Request for Class II Permissive Change(C2PC)

FCC ID: VG8XM025FXX-Y

Please be notified that we, the undersigned, **Guangdong Midea Kitchen Appliances Manufacturing Co.,Ltd.** declare that the reasons for this class II permissive change are as below:

1. Changed Mother -board as below.

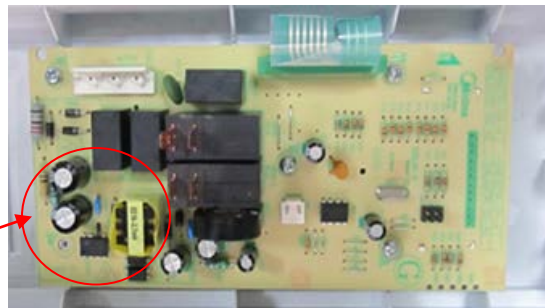
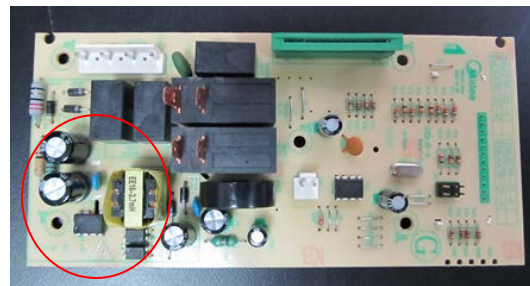
- 1.1 Line transformer change to Switching power supply.
- 1.2 They have the same input&output power and similar circuit function.
